**REVISED RESPONSE TO REQUEST FOR ADDITIONAL INFORMATION****APR1400 Design Certification****Korea Electric Power Corporation / Korea Hydro & Nuclear Power Co., LTD****Docket No. 52-046**

**RAI No.:** 398-8457

**SRP Section:** 15.06.05 – Loss of Coolant Accidents Resulting From Spectrum of Postulated Piping Breaks Within the Reactor Coolant Pressure Boundary

**Question No. 15.06.05-5**

Figure 1 Core flush by hot side injection

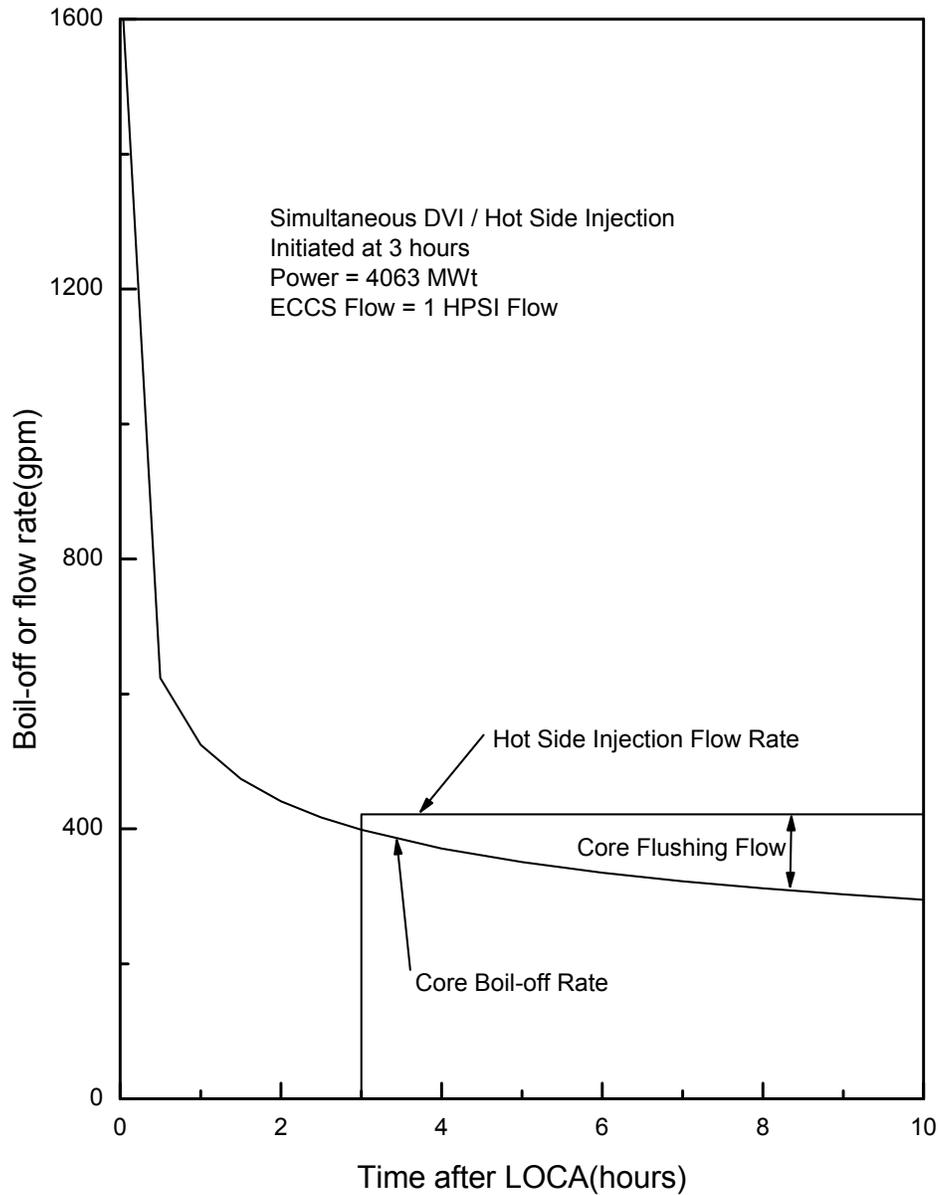
2. The analysis does not appear to account for reduced injection flow during the switchover to hot leg injection at 3 hours (Section 3.5.4). Is there a reduced flow during this transition period and how is it addressed in the calculation?

The injection flow is not considered to decrease during the switchover to hot leg injection. Instead, the injection flow is assumed conservatively. The flushing flow rate is calculated by hot side SI injection flow and core boil off rate as shown in Fig.1. Even though 2 SI pumps actuate during the switch over period, it is assumed that 4/10 of the total flow from a single SI pump enters the reactor vessel from the hot leg and all of the decay heat from the core boils off liquid. At 3 hours, core flushing flow is decreased to 23 gpm. After 3 hours, as the core boil off rate has decreased, the core flushing flow has increased. The flushing flow rate is used to compute the boric acid concentration in the core.

Figure 5. Inner Vessel Boric Acid Concentration vs. Time

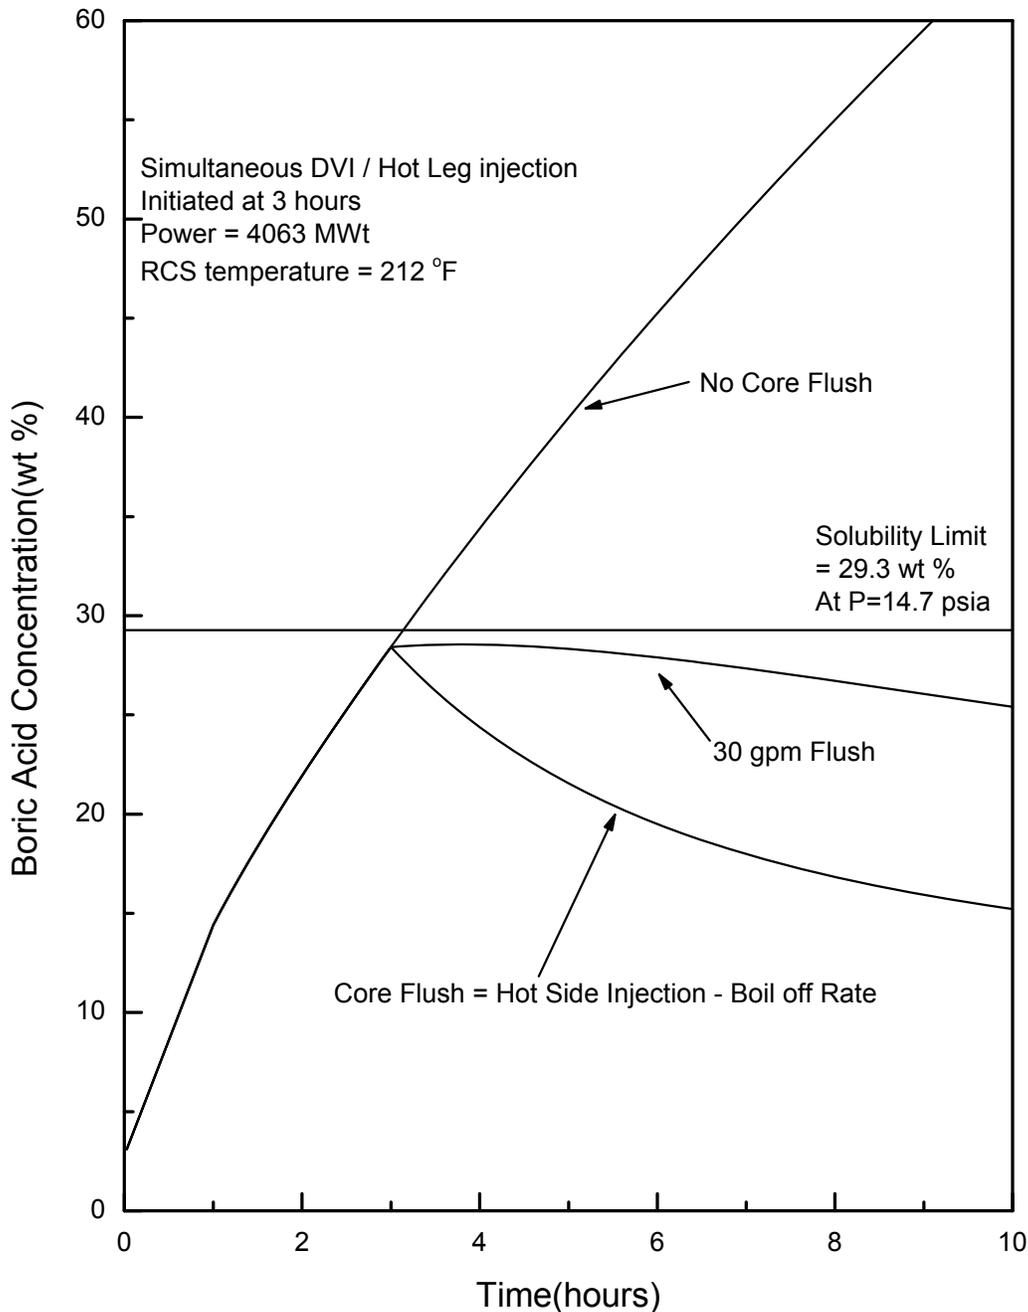
13. Figure 4-3 shows the buildup of boric acid concentration which depends on the boiloff rate and appears to be independent of break size? For smaller breaks where natural circulation is mixing the coolant, the switch to hot leg injection could possibly hinder the natural circulation by introducing cold liquid into the hot side of the natural circulation loop. How does the approach used address this possibility?

The double ended cold leg break size is the limiting break for long term boric acid accumulation in the inner vessel region, because the largest amount of coolant with high boron concentration is added to the inner vessel from SITs and SI pumps. Therefore, only the double ended cold leg break size is considered to calculate boric acid concentration by the BORON code. Thus, the boric acid concentration for the double ended cold leg break size is depicted in Figure5.

The mixing volume for computing the boric acid concentration is changed to include the additional volume from the top of the core to the top of the hot leg piping at the RV outlet nozzles. If the water level in the inner vessel is higher than the top of hot leg, boron precipitation is not a concern. Natural circulation is not considered in the BORON code because natural circulation begins when injected water refills to the top of the steam generators, in the case of smaller break sizes.

Even though the switch to hot leg injection could possibly hinder the natural circulation by cold water; boron precipitation does not occur around the top of the core. Thus natural circulation is not addressed in the BORON code.

Figure 6. RCS Pressure after Refill vs. Break Area

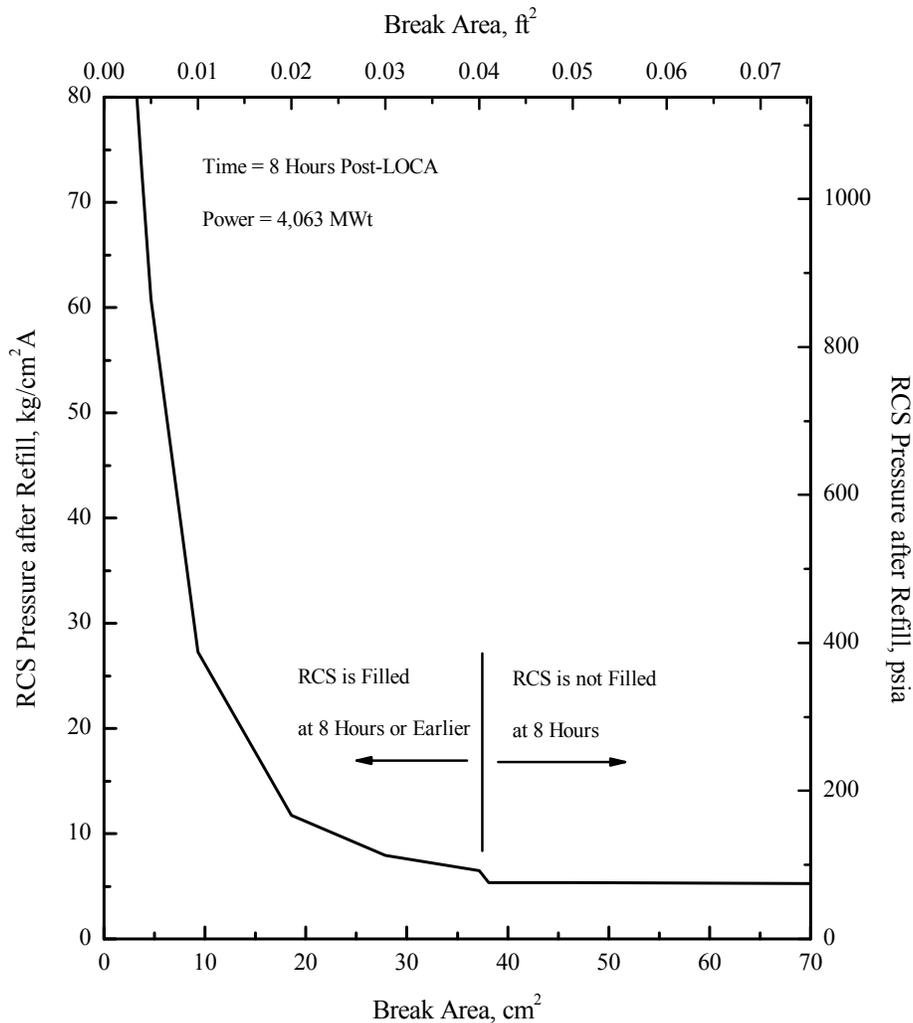
14. In the CENPD-254 methodology, the maximum break size for the small break analysis is determined by the auxiliary feedwater capacity. There is no mention of auxiliary feedwater capacity in the technical report. How was the upper limit size determined for the small break?

The decision time at which the operator decide whether to use the large break procedure or the small break procedure in order to continue the cooldown of the RCS. This time (8hr) is determined between the earliest time at which the SDC entry conditions can be achieved, and the latest time for which auxiliary feedwater can be assured to be available.

In order for the SDC system to be used to remove heat from the RCS, there must be sufficient liquid in the hot leg from which it takes suction. If RCS is refilled before the decision point time, the break case is assured of having sufficient coolant in the RCS to use the SDC system. Thus, the decision time determines the upper limit size of small break for which the SDC system can be used. This break size is 0.04 ft<sup>2</sup> as is shown in Figure 6 below.
